Replaceable Clutch Stop

Subject: Replacement of welded-in pin style clutch stop.

Units Affected: WSES, RH, WSE

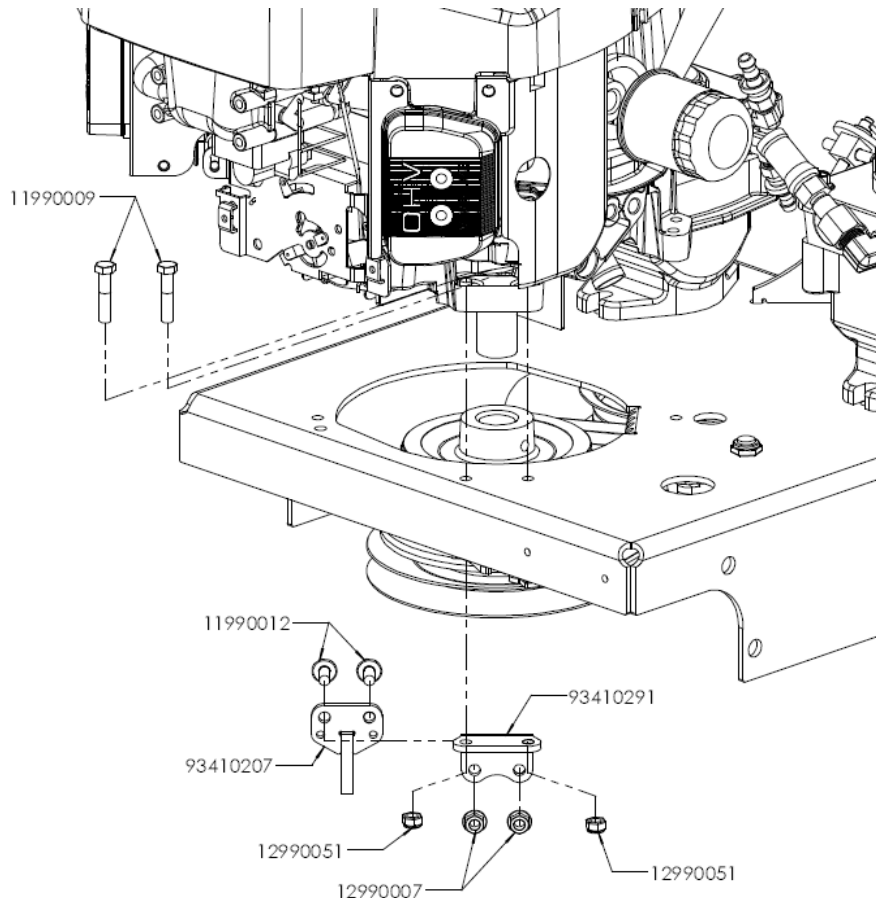
Situation: If the stop breaks, it is difficult to weld in a new piece accurately.

The Fix: Removal of the remaining pin and bolting in a new stop (95410014) using the front engine mount location.

- 1) Cut off remaining clutch stop pin but leave the engine deck structure in place to use as the wire tie location for the clutch wire.
- 2) The bolt in stop will use the front engine mounting holes, remove the original engine mounting bolt and bolt in the stop bracket using the new hardware and existing mounting holes.
- 3) The position of the stop is critical per the model being fixed. On Sentar's the flush side of the stop must face the engine shaft. On WSES/RH's the flush side of the stop must face away from the engine shaft. Slightly move the clutch to line up with the stop and bolt the stop to the stop bracket.
- 4) Once the new stop is in place, if a hydro belt has to be replaced the stop will need to be removed.
